Contract #: 04-0120F4Cty: SF/ALA Rte: 80 PM: 13.2/13.9File #: 69.28**WELDING INSPECTION REPORT****Resident Engineer:** Siegenthaler, Peter**Address:** 333 Burma Road**City:** Oakland, CA 94607**Report No:** WIR-025595**Date Inspected:** 27-Jul-2011**Project Name:** SAS Superstructure**OSM Arrival Time:** 700**Prime Contractor:** American Bridge/Fluor Enterprises, a JV**OSM Departure Time:** 1900**Contractor:** Zhenhua Port Machinery Company, Ltd (ZPMC), Changxing Island **Location:** Shanghai, China**CWI Name:** An Qing Xiang**CWI Present:** Yes No**Inspected CWI report:** Yes No N/A**Rod Oven in Use:** Yes No N/A**Electrode to specification:** Yes No N/A**Weld Procedures Followed:** Yes No N/A**Qualified Welders:** Yes No N/A**Verified Joint Fit-up:** Yes No N/A**Approved Drawings:** Yes No N/A**Approved WPS:** Yes No N/A**Delayed / Cancelled:** Yes No N/A**Bridge No:** 34-0006**Component:** OBG**Summary of Items Observed:**

SHIP # 19, OBG SEGMENT 13AE

SHIP # 19, OBG SEGMENT 14W

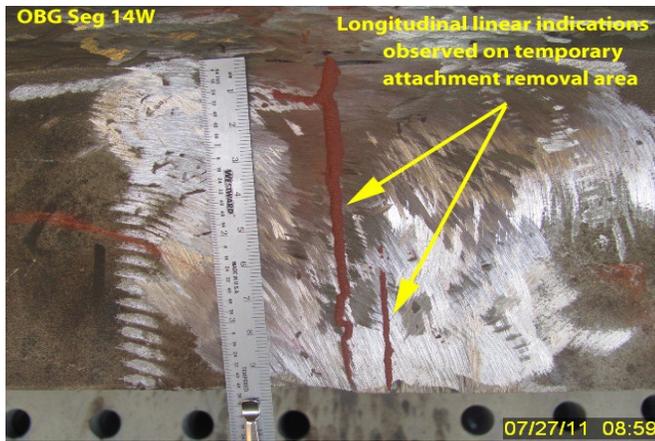
During random in process inspection this QA Inspector observed that ZPMC personnel were installing traveler rail bracket on Side Panel (SP) of OBG segment 13AE. See attached photograph for more details.

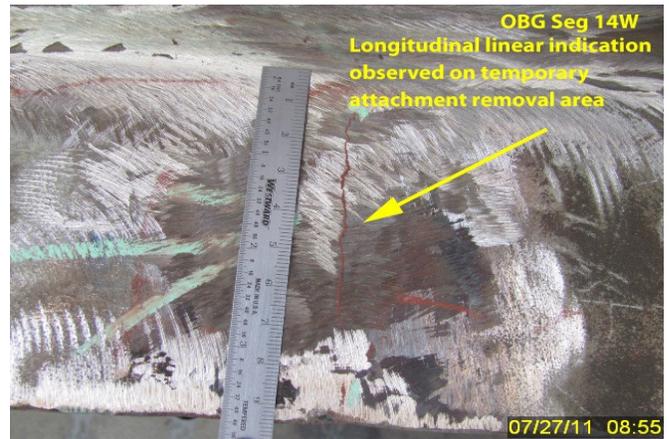
Longitudinal linear indications were observed on temporary attachment removal area on the stiffeners of top Anchorage plate (AP) 3023A at FL3 area of segment 14W during witness with AB/F Magnetic Particle Testing (MT) personnel. See attached photograph for more details.
